Technical Service Bulletin

Cobra Motorcycle Mfg.

TSB1204: 2004 CM & PW carburetor inlet covers

April 2, 2004

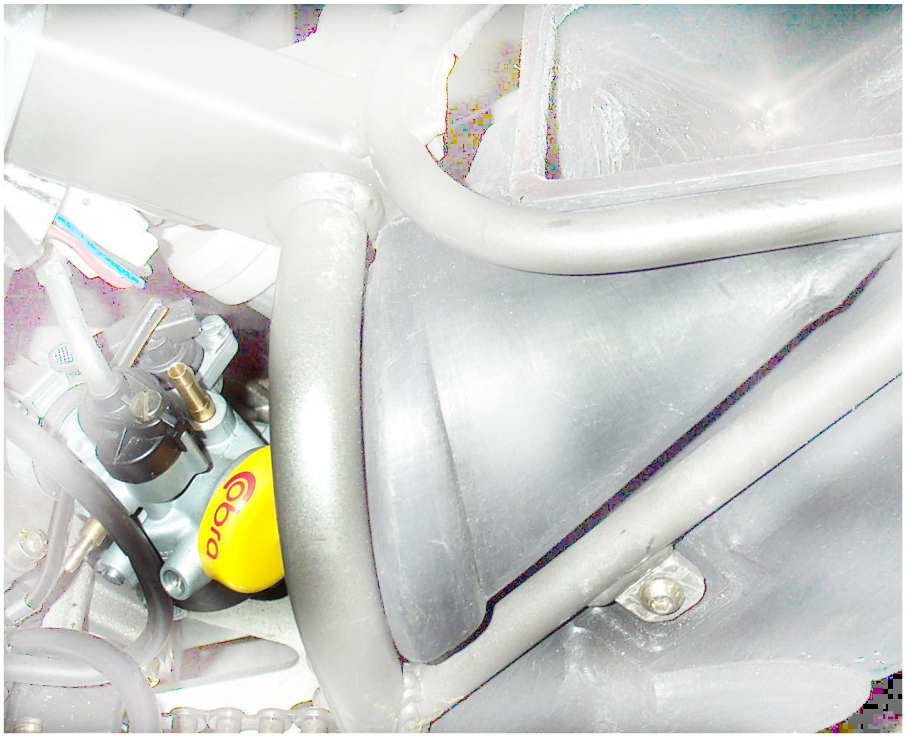
The new design of the 2004 CM & PW allows the easy and rapid cleaning of the airbox with a hose by simply removing the air filter. This process can allow pressurized dirt and/or water to enter the carburetor unless the opening of the carburetor is properly covered. Cobra has a carburetor cover available that fits both the CM & PW model.
